Access Compliance Report Public Rights-of-Way (Curb Ramps)

Intersection ID: 10917 Main Street: E_25TH_ST Cross Street: N_DAVIDSON_ST Location: S

ADA ID: D5D687E7BC57 Ramp Type: PerpDiag Initial Pass/Fail: Fail Overall Compliance: No Severity Score: 47.5

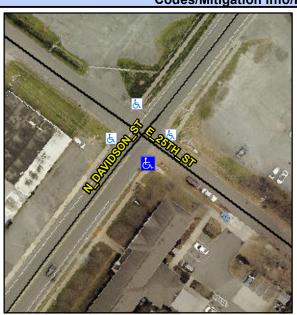
Not Found, R304.5.1, R304.2.2

Field Measurements/Component Compnance						
	Comp	Compliance Description		Compliance Description		Data
	N/A	Ramp Length (in)	46.5	No	Ramp Slope (%)	10.0
	No	Ramp Width (in)	31.5	Yes	Ramp XSlope (%)	1.0
	N/A	Flare Type LT	N/A	N/A	Flare Type RT	N/A
	N/A	Flare Slope LT (%)	N/A	N/A	Flare Slope RT (%)	N/A
	N/A	Flare Traversable LT?	N/A	N/A	Flare Traversable RT?	N/A
	N/A	Landing Length (in)	N/A	N/A	DWS Provided?	N/A
	N/A	Landing Width (in)	N/A	N/A	DWS Contrast?	N/A
	N/A	Landing Slope (%)	N/A	N/A	DWS Length (in)	N/A
	N/A	Landing X Slope (%)	N/A	N/A	DWS Full Width?	N/A
	N/A	Landing Curb? (Y/N)	N/A	N/A	DWS Offset (in)	N/A
	N/A	Shared Landing?	N/A			
	N/A	Gutter Ponding?	N/A	N/A	Gutter Slope (%)	N/A
	N/A	Gutter Lip Ht (in)	N/A	N/A	Gutter X Slope (%)	N/A
	N/A	Painted X Walk1?	No	N/A	Painted X Walk2?	No
		X Walk 1 Direction	To NE		X Walk 2 Direction	To NW
	N/A	X Walk 1 Width (in)	N/A	N/A	X Walk 2 Width (in)	N/A
		X Walk 1 Slope (%)	2.6		X Walk 2 Slope (%)	3.5

Remove & Replace Curb Ramp With Two New Directional Ramps or Equivalent.
